Commonwealth Edison

Subject: Braidwood Station Units 1 and 2
Additional FSAR Information
NRC Docket Nos. 50-456/457

The Attachment to this letter provides our response to Questions 10.60, 10.62, 361.1 thru 361.5, 362.1, 362.10, 371.9, 371.10, 371.19 and 372.23. Our FSAR will be amended to include the information contained in the Attachment to this letter as appropriate. Additionally, our schedule for submittal of the remaining open items is currently being discussed with Ms. Janice A. Stevens.

BRAIDWOOD STATION
FINAL SAFETY ANALYSIS REPORT
FIGURE Q362.1-20
LOCATIONS OF OPERATIONAL SETTLEMENT MONUMENTS

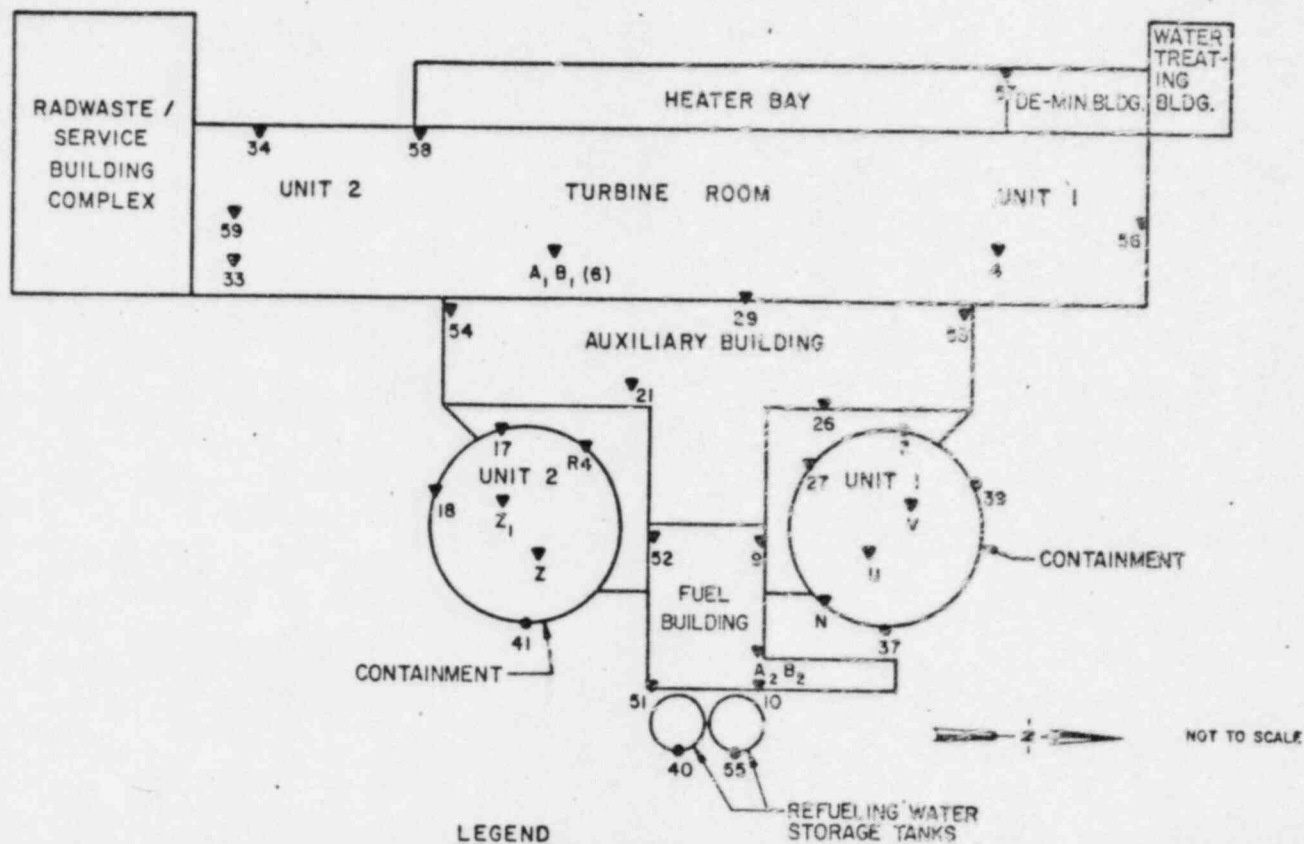
"Submit time-settlement plots for all Category I structures where settlements are being monitored. The plots should be up-to-date. Tabulate values of measured maximum differential settlements and anticipated differential settlements assumed in the analysis of these structures and appurtenances such as connecting pipes and conduits. Evaluate the impact of any differences between the measured and the anticipated settlements on the design and construction of these facilities. Unless the applicant can demonstrate that adequate settlement margins are presently available and that future settlement will be negligible, the staff will require that the total and differential settlement of the safety related structures be monitored for a period of 5 years after issuance of the Operating License. The impact of observed settlement, if any, on the design limits of Category I structures and appurtenances should be evaluated annually during this period and reported to the NRC."

In September 1981, a new set of operational settlement monuments was established throughout the plant. The intent of monitoring these monuments was to provide additional data to show that plant settlement under full static load is complete. The new monuments were installed on two floor levels which will reduce errors introduced into survey circuits by eliminating excessive traveling between different building levels. The locations of the operational settlement monuments are shown in Figure Q362.1-20. Time settlement plots for all the operational settlement monuments are presented in Figures Q362.1-21 through Q362.1-31.

FIGURE 2.5-12
REGIONAL STRUCTURE CONTOURS ON TOP OF
THE GALENA GROUP

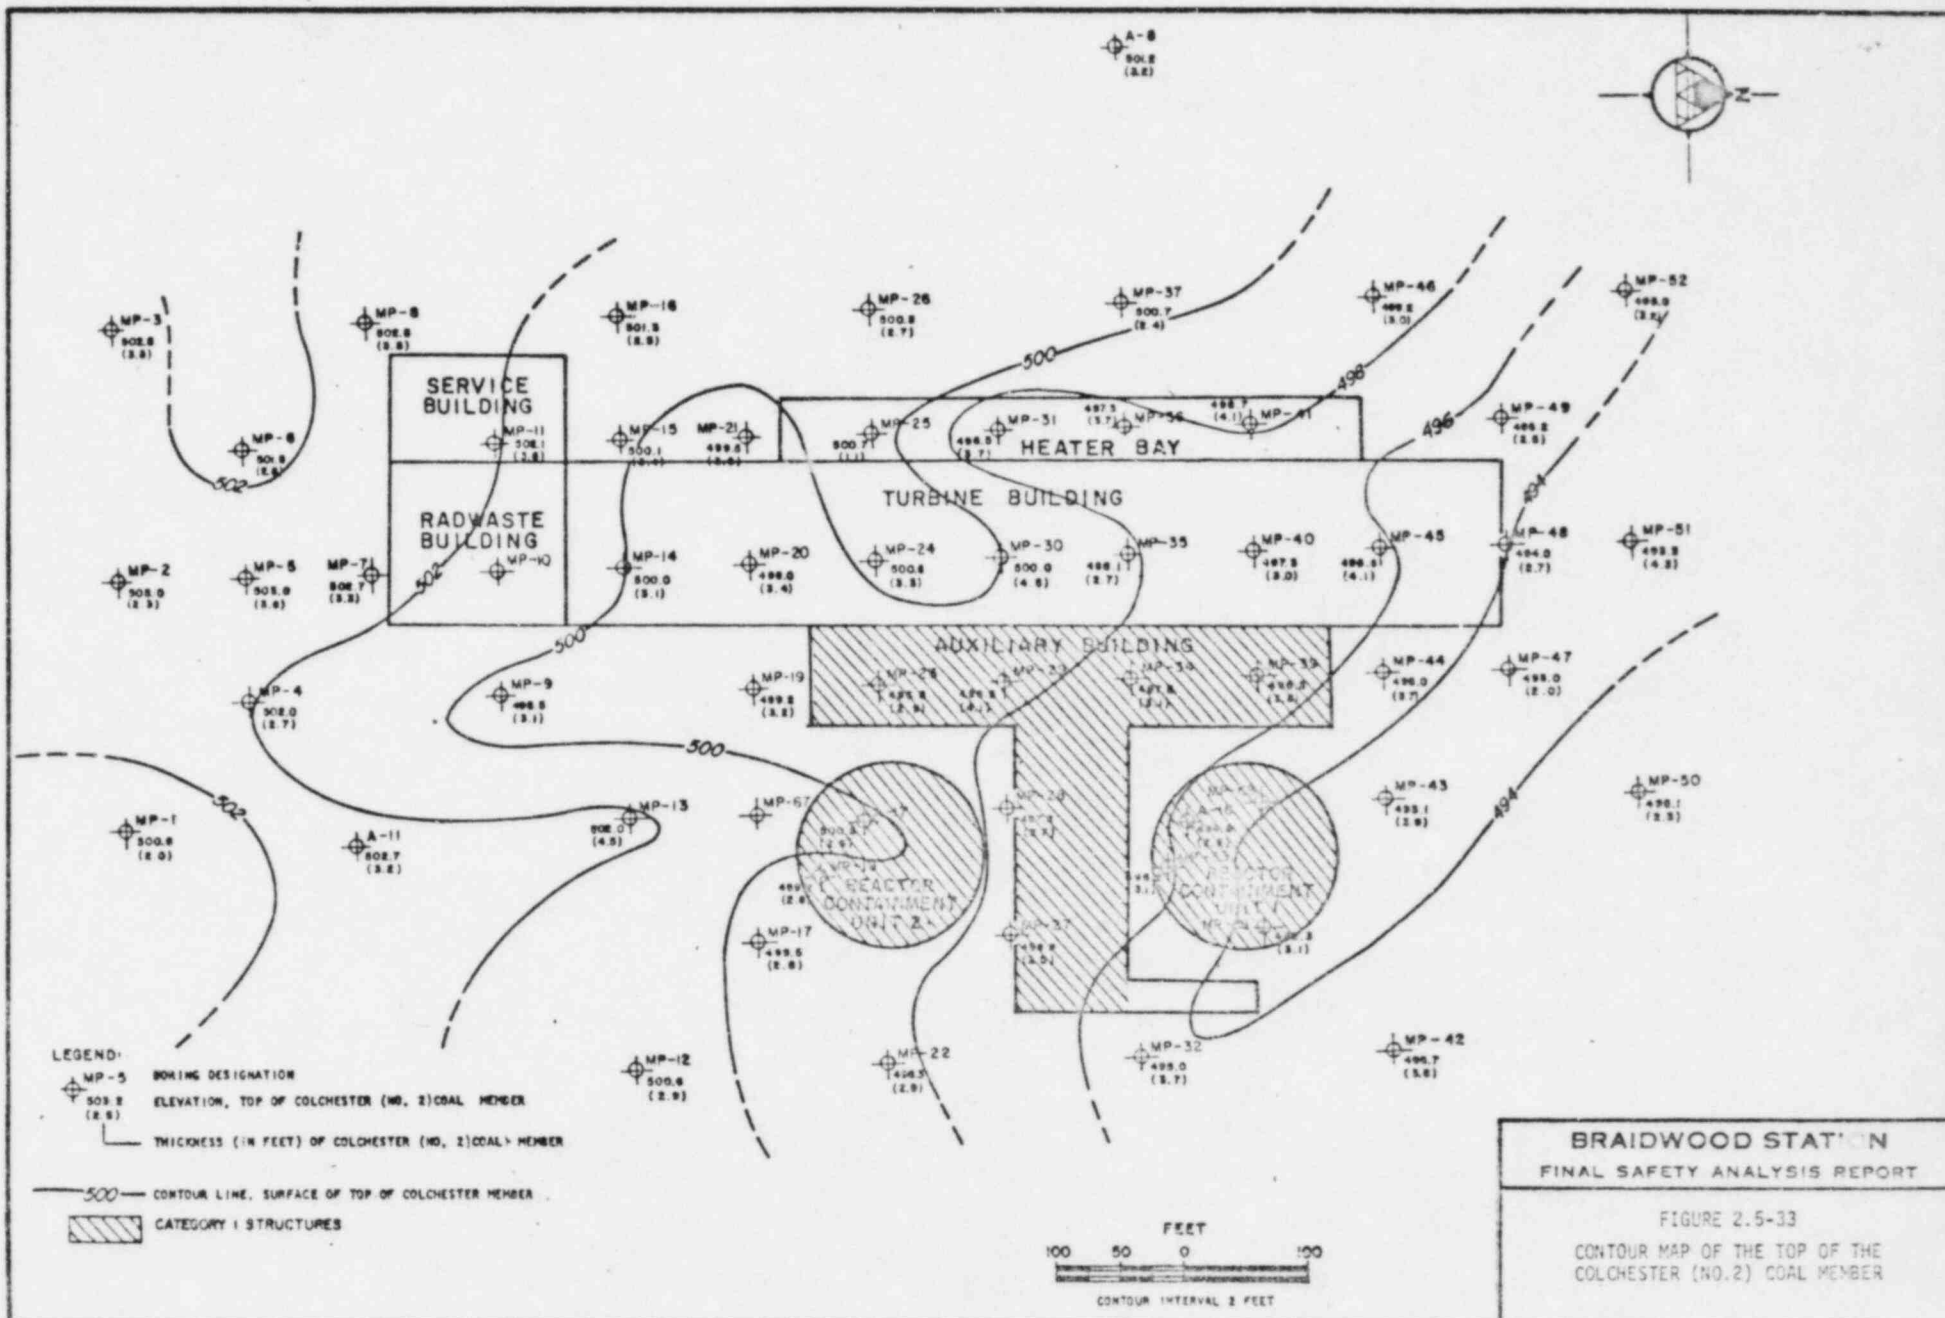
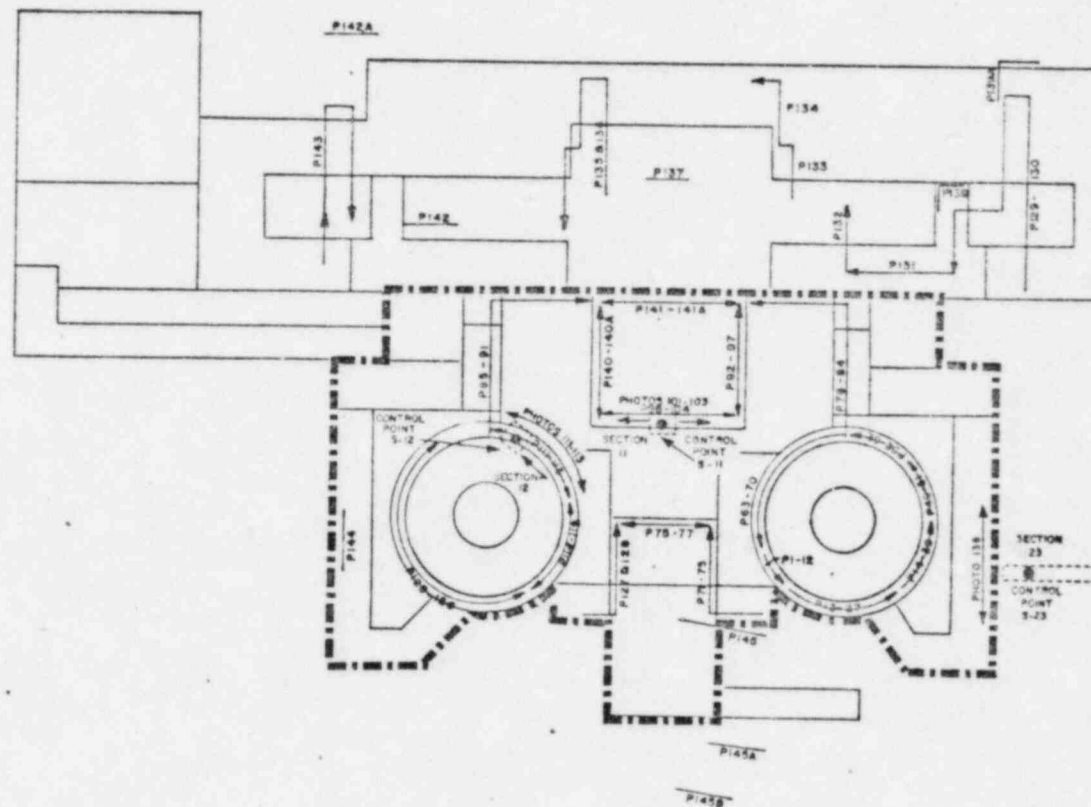
"The inset note on Figure 2.5-12 states that structural details of the area on Fig. 2.5-12 are shown in Fig. 2.5-9a. Fig. 2.5-9a apparently has not been submitted yet. Please provide the figure."

The figure referred to on the inset note on Figure 2.5-12 should be Figure 2.5-11, not Figure 2.5-9a. Figure 2.5-12 has been revised and will be included in the next amendment.

STRUCTURAL DETAILS
OF THIS AREA
SHOWN ON FIGURE
2.5-11

- "(a) Figure 2.5-55 indicates the location of excavation mapping reported on in the FSAR. Three locations are indicated as having been mapped, with Figures 2.5-49-2.5-54 illustrating these three localities. In view of the fact that these three locations represent a very small portion of the exposed bedrock in the excavations, and there is well-developed jointing evidence in two of the photographs, the staff would like to examine the 190 photographs of the 145 locations in the excavations referred to in Section 2.5.4.3.1.1.2, p. 2.5-68. Please mark them clearly as to location and direction of viewing on the photos and on the excavation location map.

- Item a: A map showing the locations of the photographs is given in revised Figure 2.5-55. One set of these photos is presently available. The NRC is welcome to view these photographs at any time.
- Item b: The primary purpose of the geologic mapping of the excavations for Category I structures at the site was to confirm that the site stratigraphy as exposed in the excavations was in agreement with that evaluated by the boring program and presented in the PSAR. Another purpose of the excavation mapping program was to ascertain that no faults were present in any of these excavations. Faulting is discussed in Subsection 2.5.1.2.5.3. No data on joint orientation or spacing was collected during the excavation mapping program. A discussion of site jointing is presented in Subsection 2.5.1.2.5.1.

FIGURE 2.5-72
FOUNDATION EXCAVATION PLAN

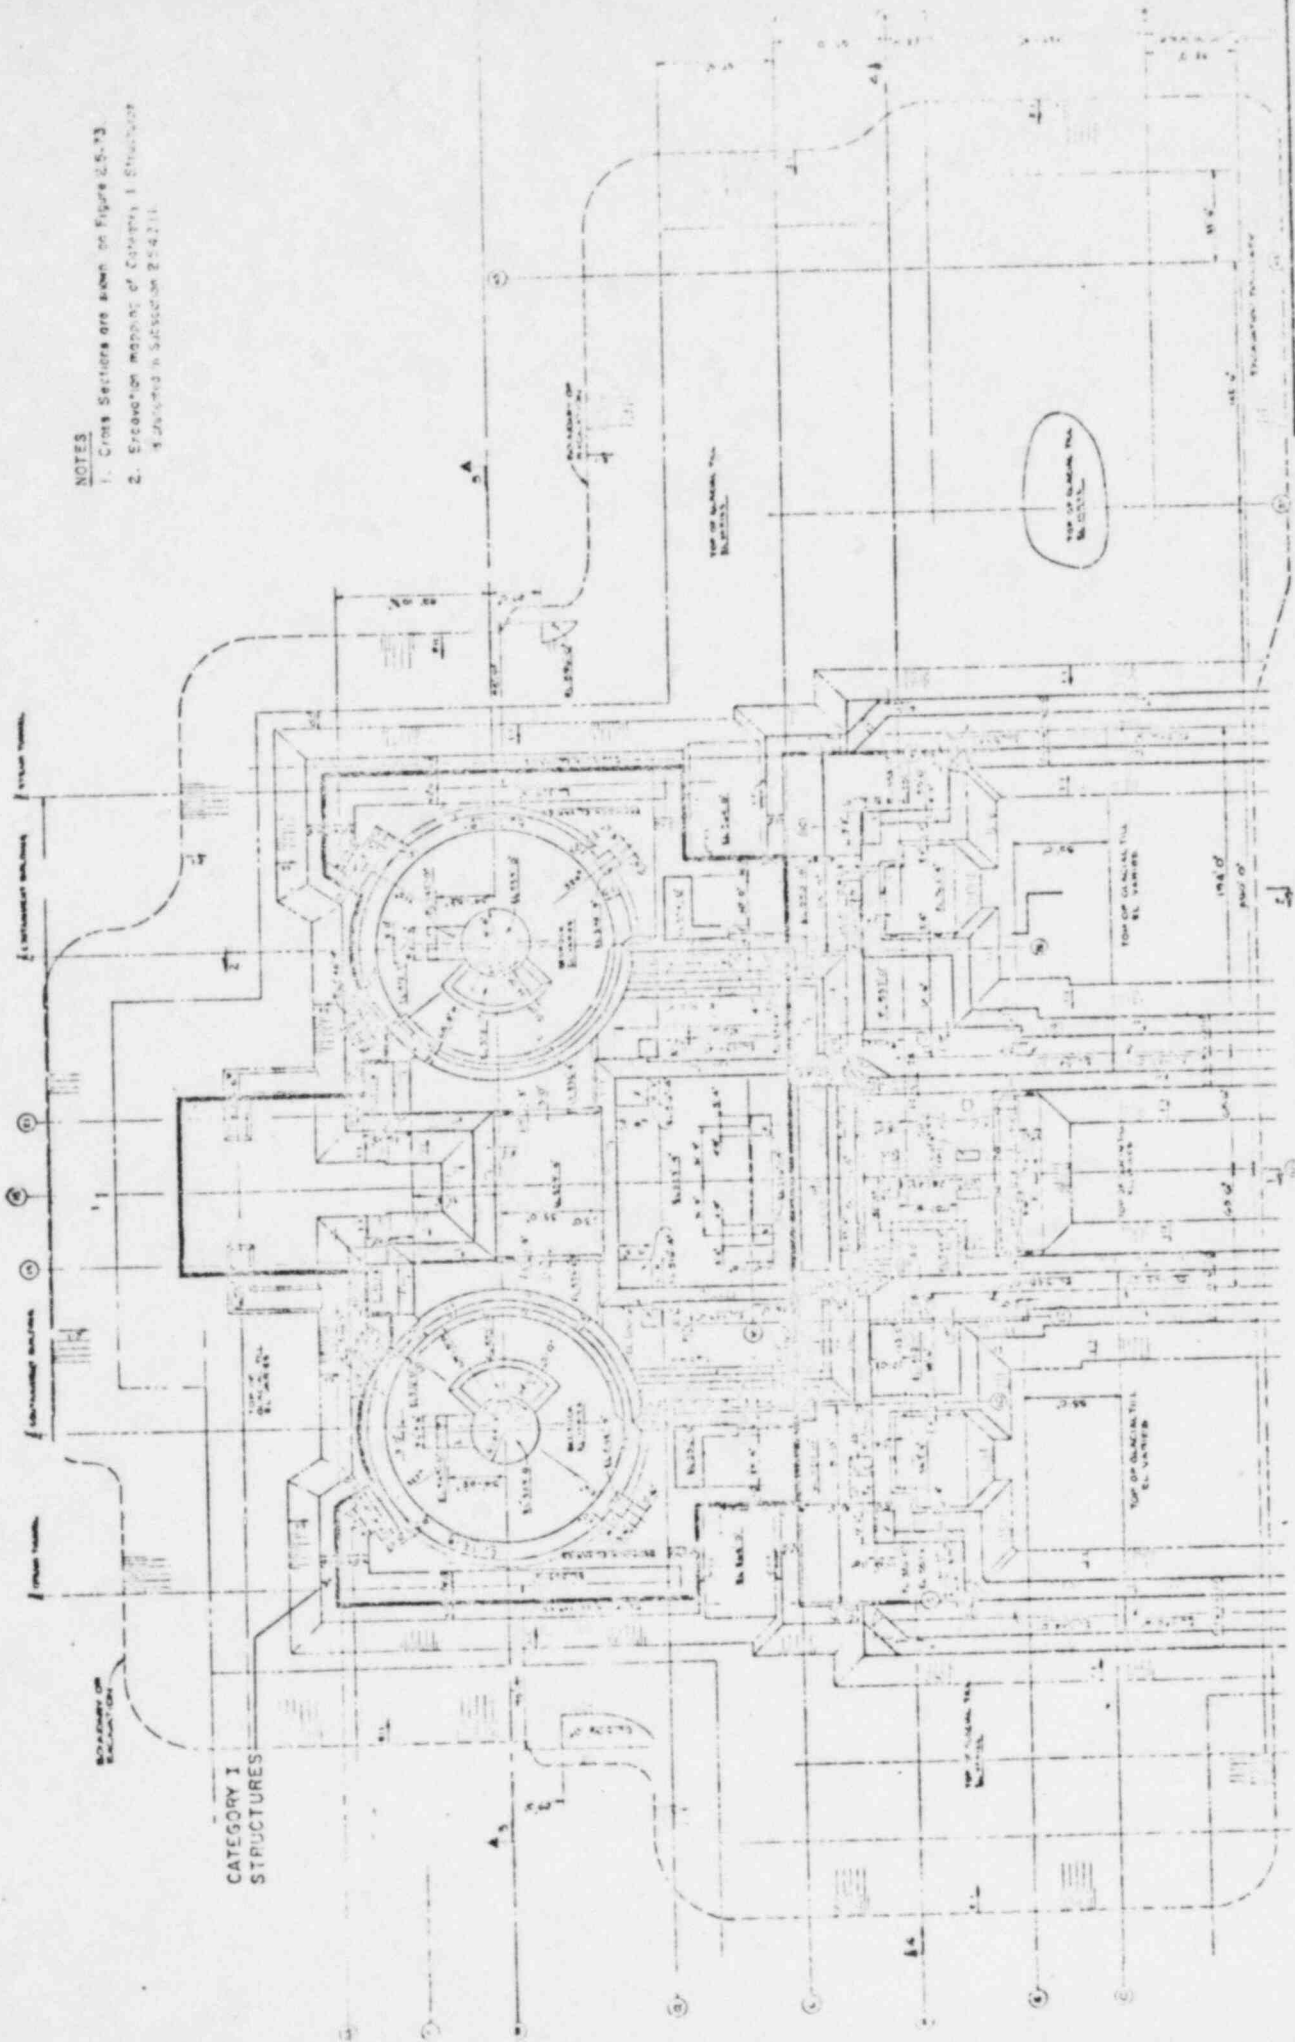
- "(c) A note on Figures 2.5-72 and 2.5-73 states that 'excavation mapping of Category I structures is presented in Attachment 2.5A'. However, 2.5A is a letter from the Illinois Geological Survey that describes a visit by IGS staff to the excavation. Please clarify."

Item c: The geologic mapping of the excavations for the Category I structures is discussed in Subsection 2.5.4.3.1.1. The note on Figures 2.5-72 and 2.5-73 has been changed to give the proper reference, and will be included in the next amendment.

1. Cross Sections are shown on Figure 2.5-73
2. Excavation mapping of Category 1 Structures is shown in Section 2.5-71.
